National Biodiesel Ltd
ABN 12 119 403 539
P.O. Box 524, Pymble NSW 2073
Suite 16, 33 Ryde Road, Pymble NSW 2073
Tel: +61 (0)2 9499 8291/2/3/4
Fax: +61 (0)2 9499 8295
Email: info@natbiogroup.com
Web: www.natbiodiesel.com

Please find outlined on the following pages our formal response to comments and requests for further information provided by the Port Kembla Coal Terminal and Port Kembla Port Corporation (refer Appendix 1), GrainCorp (refer Appendix 2) and NSW Office of Water (refer Appendix 3).

APPENDIX 1: Response to Comments Offered by PKPC and PKCT

APPENDIX 2: Response to Comments and Request for Further Information by GrainCorp

Figure 2: Location of frog exclusion fences specified by Dr A. White for management of the GGBF on the Project sites

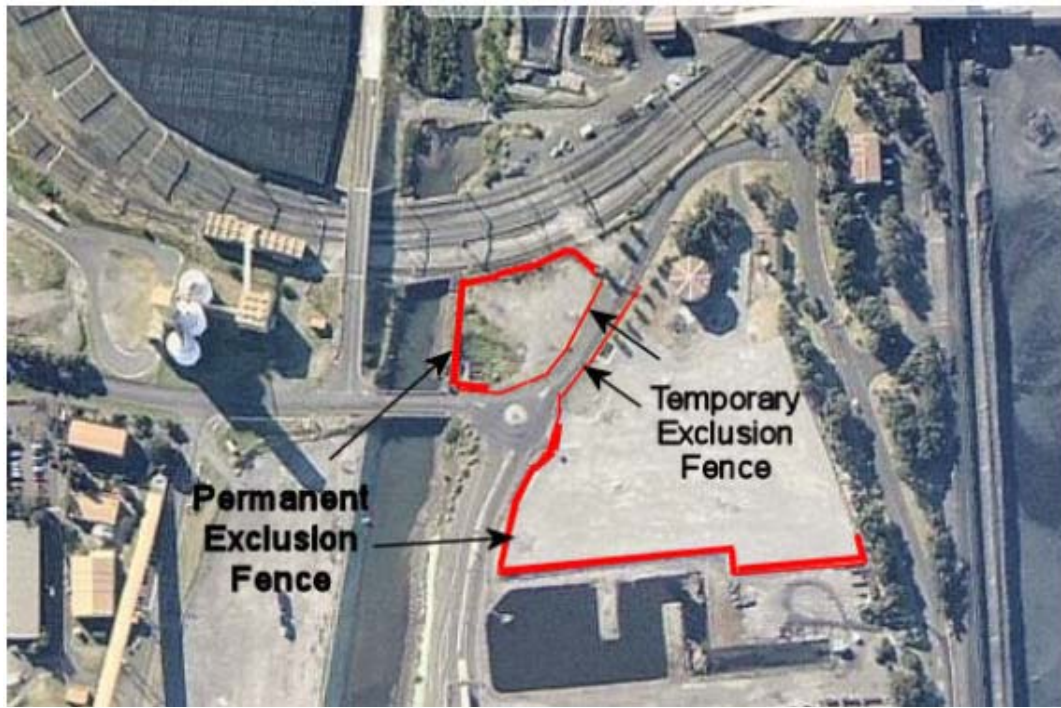
proposed changes by an accredited herpetologist, Dr A. White, from Biosphere Environmental Consultants. In this report Dr A. White identified that *“it would not be in the interests of the conservation of this frog to try and develop habitat for this species on site”*. As such, Dr A. White proposed that a permanent frog exclusion fence be established along the top of the western embankment of Allotment 6 to prevent the Green and Golden Bell Frog from straying on to this site, as outlined in Figure 2 below.

In light of the specified location of this permanent frog exclusion fence and the recommendation to not establish habitat for the Green and Golden Bell Frog on the project sites, it is not feasible to install a 10m wide riparian corridor along the western boundary of Allotment 6 as proposed by the Department of Water and Energy in 2008. On the waterway side of this permanent frog fence running along the western boundary of Allotment 6, National Biodiesel will ensure that the riparian zone is rehabilitated and maintained with appropriate endemic species as per Schedule 3 of the original Project Approval.
